Architectural Review Board Agenda  
4:00 PM Wednesday, February 1, 2023  
Sussex Civic Center – Village Board Room Second Floor

## MEMORANDUM

TO: Architectural Review Board  
FROM: Gabriel Gilbertson, Community Development Director  
RE: ARB meeting for February 1, 2023  
DATE: January 24, 2023

1 ARCHITECTURAL SITE PLAN  
1" = 40'-0"

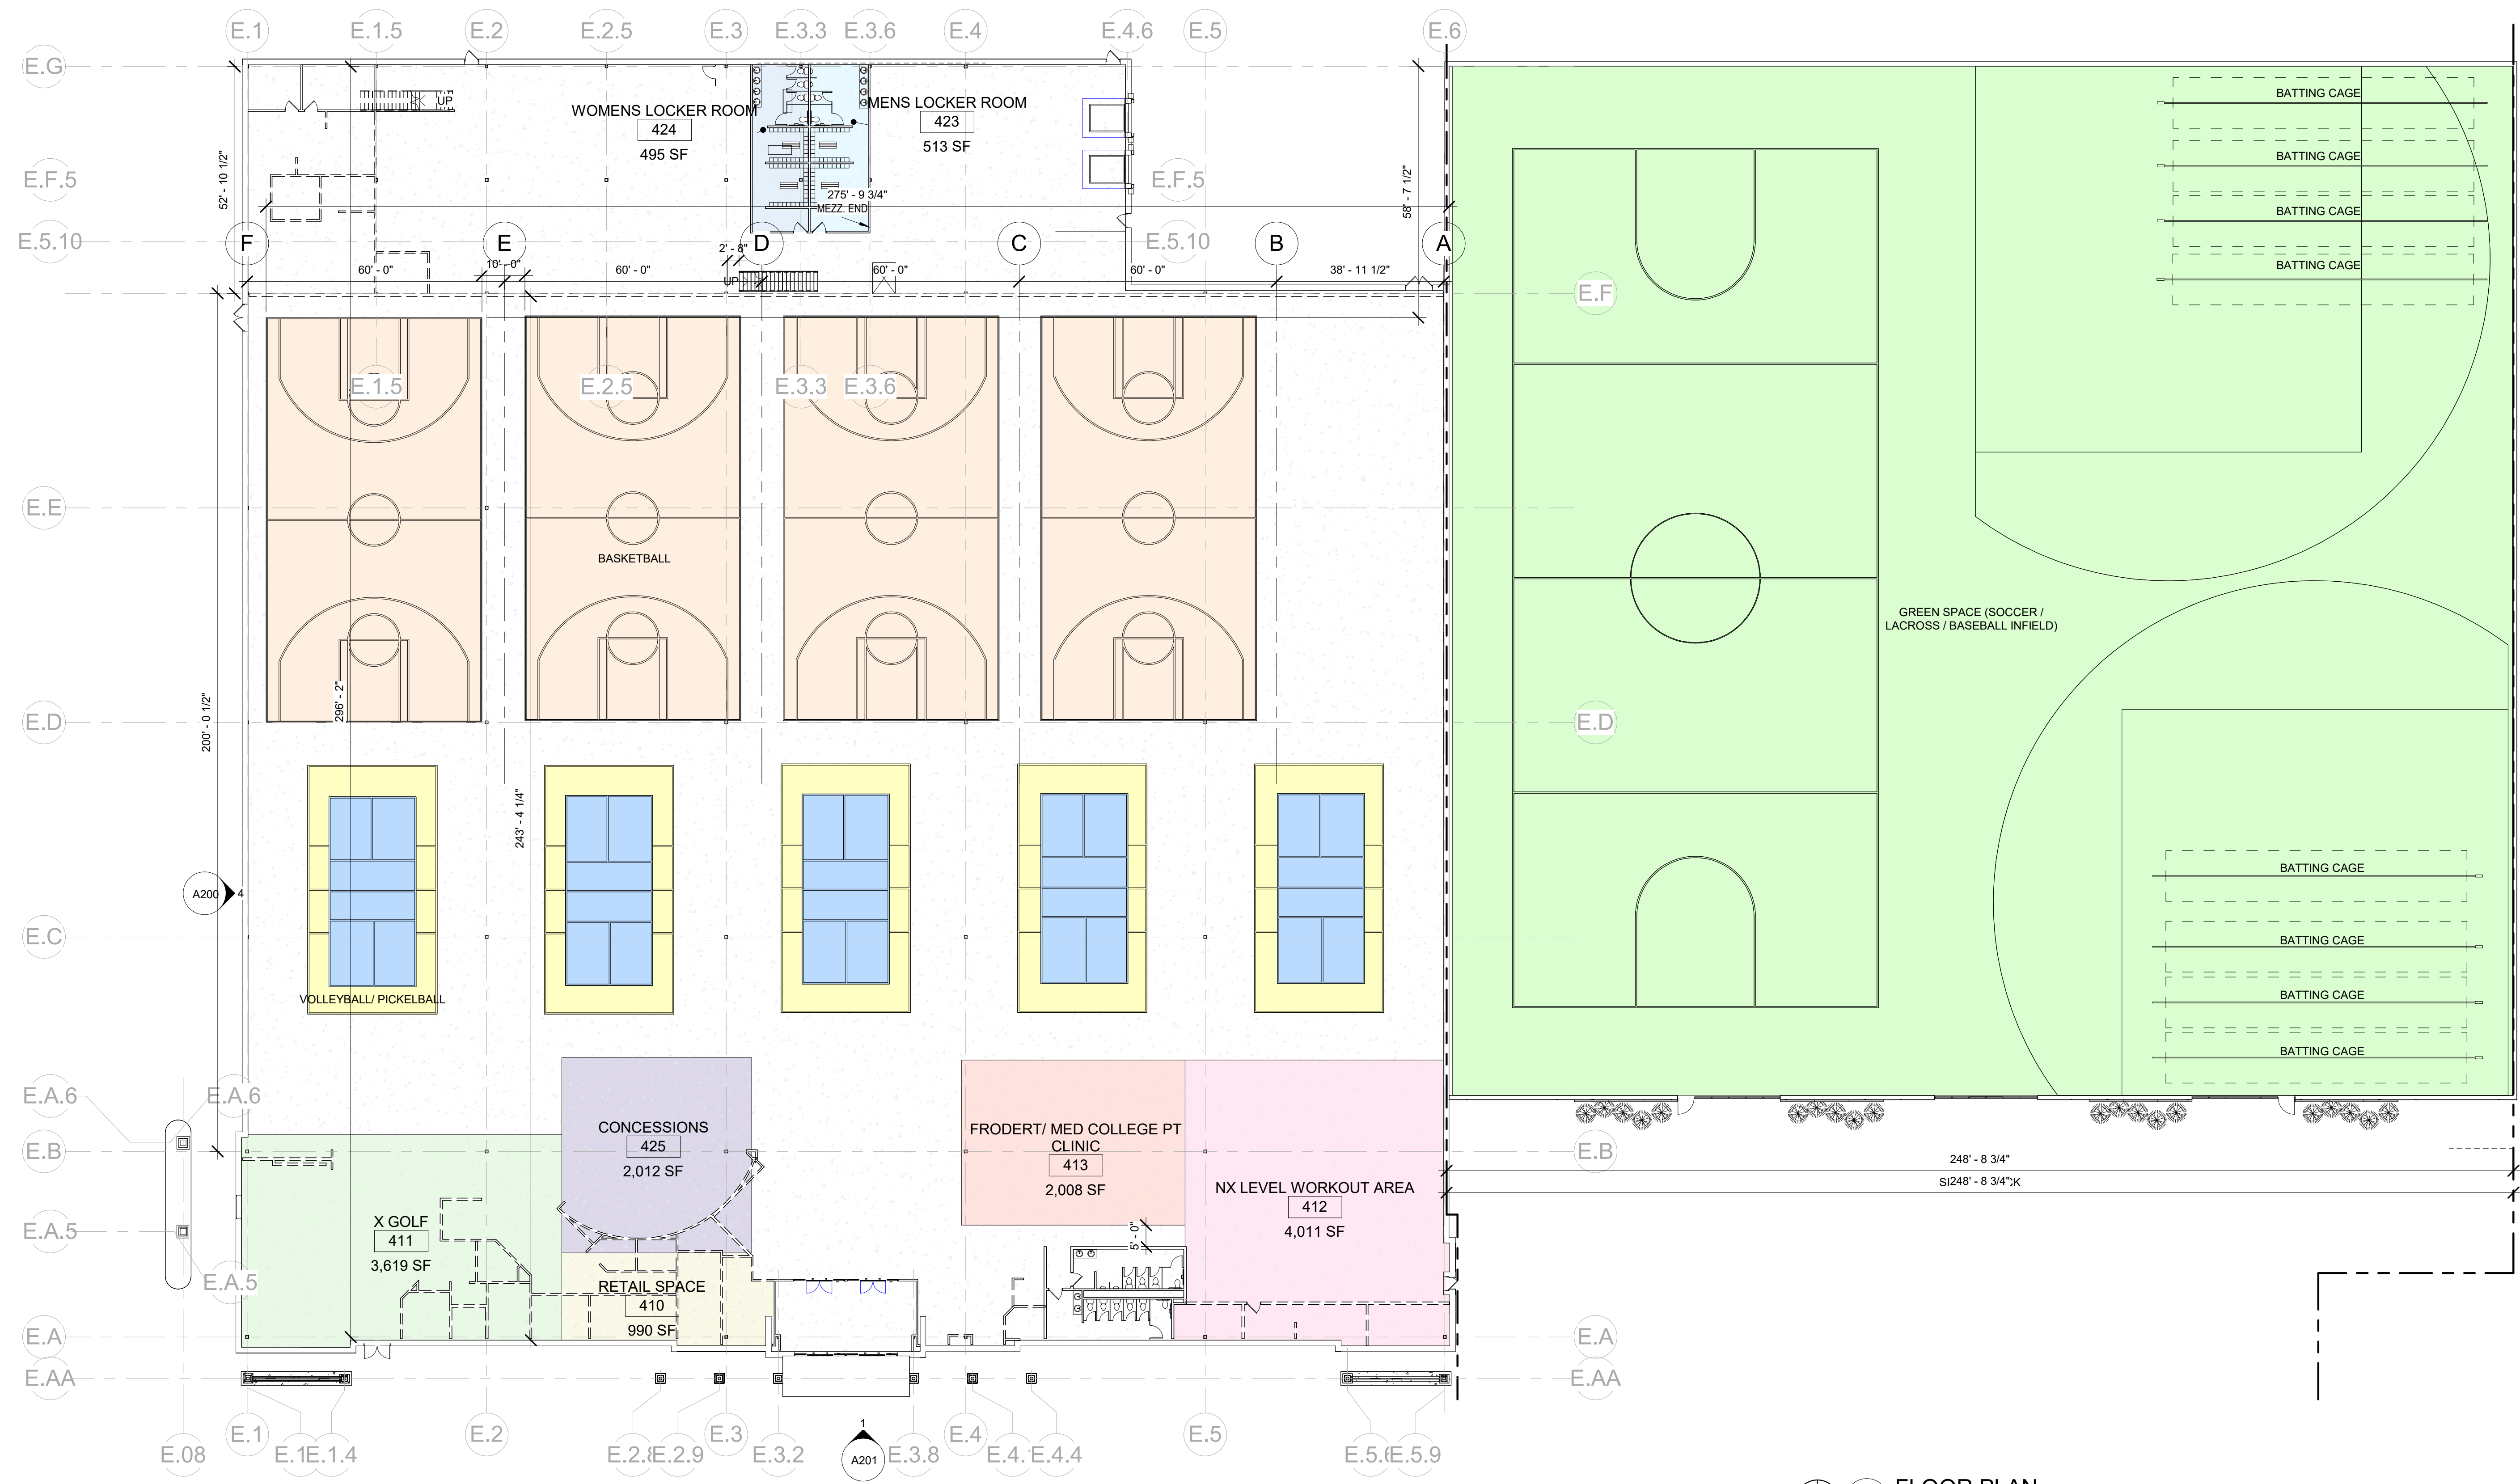
- Site to maintain 479 parking spaces (133 spaces required).
- No other modifications to the site proposed at this time. The plans have a possible building addition in the outlot between the subject building and Kohl's; however, the applicant stated that would be a second phase and is not part of this review.

ELEVATIONS

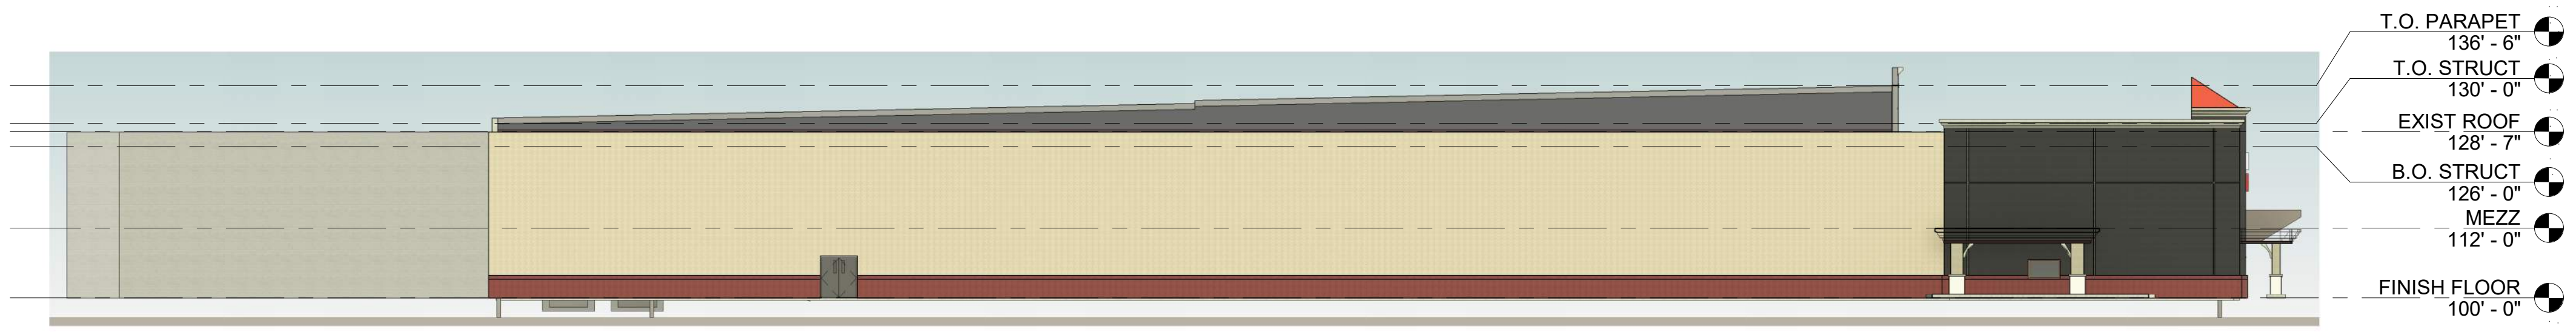
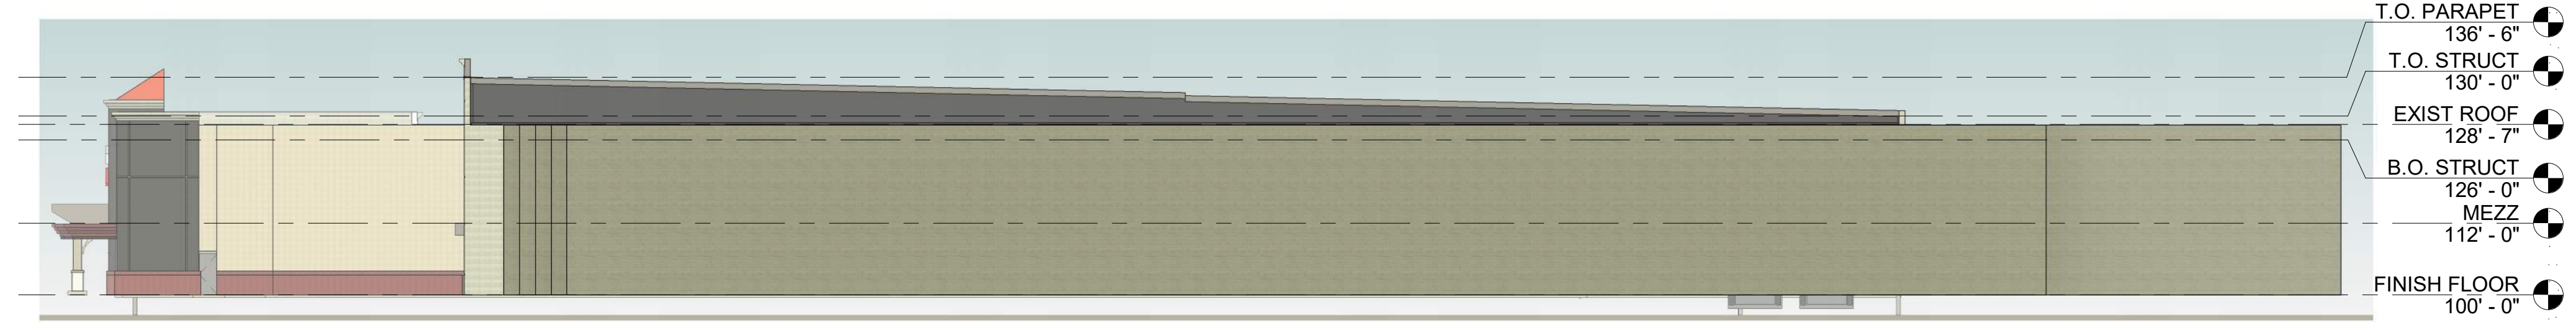
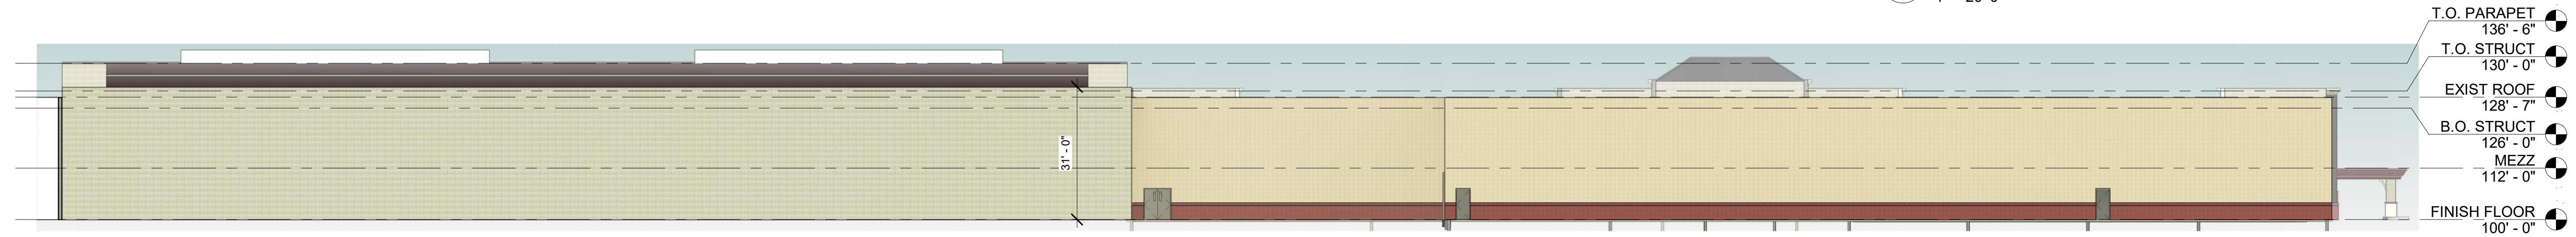
- It is an existing building and currently the applicant is only proposing to repaint the exterior and install an additional set of doors on the front elevation. Renderings and elevations of the proposed color scheme are attached.
